ECE/TRANS/WP.29/GRE/2008/15
18 January 2008

Proposal for Supplement 2 to the 04 series of amendments to Regulation No. 48
(Installation of lighting and light-signalling devices)

Submitted by the expert from France */

FIGURE (see paragraph 6. 5.)

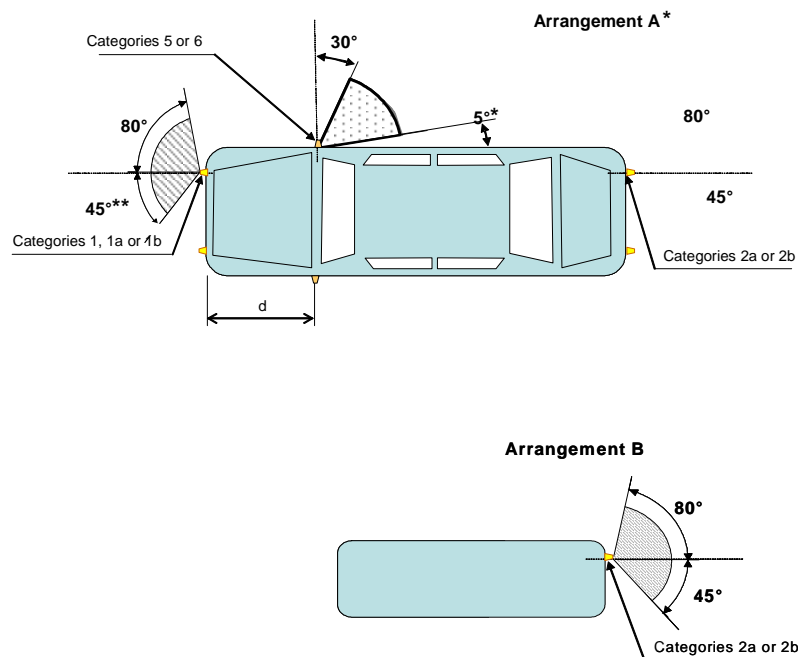
Paragraph 6.5.5.1., amend to read:

"6.5.5.1. Horizontal angles, (see figure below)

Vertical angles: 15° above and below the horizontal for direction-indicator lamps of categories 1, 1a, 1b, 2a, 2b and 5. The vertical angle below the horizontal may be reduced to 5° if the lamps are less than 750 mm above the ground; 30° above and 5° below the horizontal for direction-indicator lamps of category 6. The vertical angle above the horizontal may be reduced to 5° if the optional lamps are not less than 2,100 mm above the ground.

(*) The value of 5° given for dead angle of visibility to the rear of the side-direction indicator is an upper limit. $d \leq 1.80$ m(for M₁ and N₁ category vehicles $d \leq 2.50$ m).

(**) The value of 45° for the front direction indicator maybe reduced to 20° under the HH line of this lamp."

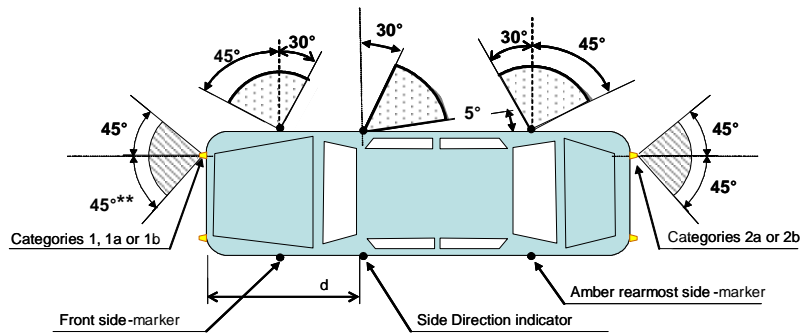
Paragraph 6.5.5.2., amend to read:

"6.5.5.2. or, at the discretion of the manufacturer, for M₁ and N₁ category vehicles (***):

Front and rear direction-indicator lamps, as well as side-marker lamps

Horizontal angles see figure below:

Vertical angles: 15°

(***) The value of 5° given for dead angle of visibility to the rear of the side-direction indicator is an upper limit. $d \leq 2.50$ m." (for M₁ and N₁ category vehicles $d \leq 2.50$ m)."
